ZERO TURN SERIES (Steering Wheel)

Parts Affected: **703-08882 / 703-08882A** LH Speed Cam Plate.
703-08883 / 703-08883A RH Speed Cam Plate.

Date: June 30, 2016

Subject: **9.0" Speed Cam Alignment Tool 753-08599.**

FIGURE 2

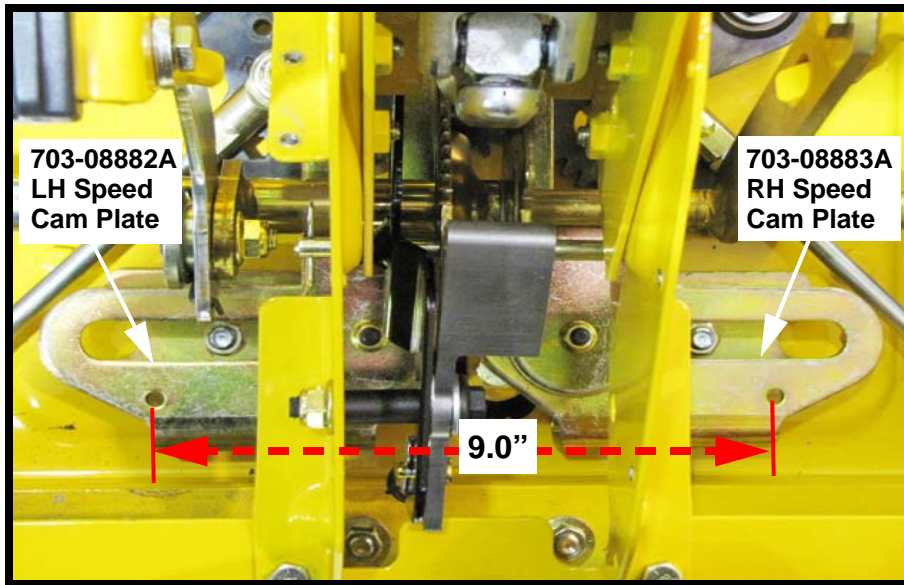
A change was made to the left hand (**703-08882**) and right hand (**703-08883**) Speed Cam Plates. The new speed cam plates, left hand (**703-083332A**) and right hand (**703-08883A**) require the new 9.0" speed cam alignment tool (**753-08599**) for proper neutral and steering timing procedures.

To identify which speed cam plates are present on a 2012 through 2015 zero turn steering wheel model, measure the dimension from the center of the outer hole of the left hand speed cam plate to the center of the outer hole of the right hand speed cam plate.

The (703-08882) and (703-08883) speed cam plates will measure 8.0". from outer hole to outer hole. These are the production speed cam plates used from 2012 through 2015.

If the speed cam plates have been replaced on a 2012 through 2015 zero turn steering wheel model with the (703-08882A) and (703-08883A) speed cam plates, the speed cam plates will measure 9.0". from outer hole to outer hole as shown in Figure 2.

NOTE: *When replacing one side, the opposite side must be replaced along with it. Can not mix a (703-08882) left hand with a (703-08883A) right hand.*
